HDC-2023-00045

Address: 449 N. 10th Street

District: Old Allentown Historic District Applicant: Muhammad Aqib Zafar, owner Proposal: Install signage at storefront

# Historical Architectural Review Board COA Final Review Sheet

Proposed location of signage. (Applicant)

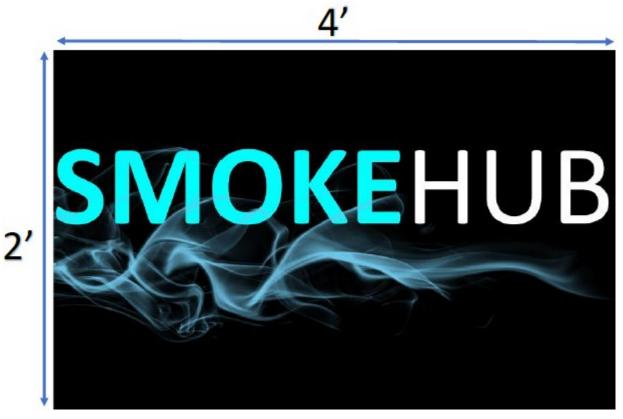
The proposed signs comply with Guidelines 3.13.12, 3.13.14, 3.13.15, and 3.13.16, because they would appropriately located above the storefront windows, would be easily reversible with no damage to historic fabric, and are of a size and scale that are appropriate for the building. However, the signs, proposed to be vinyl stickers, do not comply with Guideline 3.13.21, which recommends a high-quality and durable material. However, the guidelines do allow for surface-applied window signs with high transparency in a material similar to what is proposed. Staff recommends one of the following to comply with the design guidelines:

- 1. Print or paint the signs on wood or metal; or
- 2. Install surface-applied signs within the transom of the storefront windows.

The HARB discussed where the signage should be installed. Mr. Jordan suggested limiting the signage to the space below the former lintel. Mr. Huber stated that the signage could be installed within the upper pane of glass within the storefront window or on a wood sign above. Mr. Jordan read the staff recommendation, stating that the HARB seemed to be in agreement with the staff, but added that the sign should be centered above the storefront windows but below the former lintel. The applicant agreed to the HARB's comments and presented a revised signage plan that satisfies the design guidelines.

Approval, provided the signs are metal or wood, or the proposed signs are installed within the transom of the storefront windows, with the staff to review details, pursuant to Chapter 3, Section 3.13 Commercial Storefronts.

- Install surface-applied signs within the transom of the storefront windows; or
- Print or paint signs on wood or metal and center the sign vertically and horizontally within the space below the former lintel line between the first and second stories.
